Product Change Notice (PCN)

PCN Number: PCN-0451091R-01

Product(s) Affected: PJ-043-SMT-TR

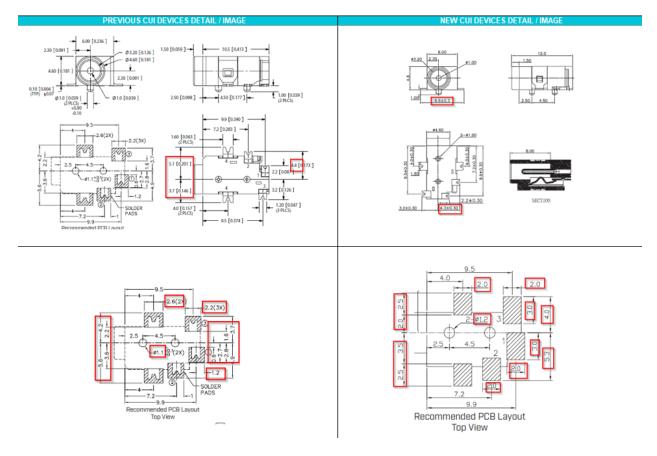
Description of Change: Minor Housing and footprint differences. Material Change on the

housing and terminals. See image Below

NEW CUI DEVICES DETAIL / IMAGE		
DESCRIPTIO	N MATERIAL	PLATING/COLOR
center pin	brass	tin
terminal 1	brass t=0.25	tin
terminal 2	SUS301 t=0.25	tin
terminal 3	brass t=0.25	tin
shield	brass t=0.25	tin
housing	PA9T (UL94V-0	D) black
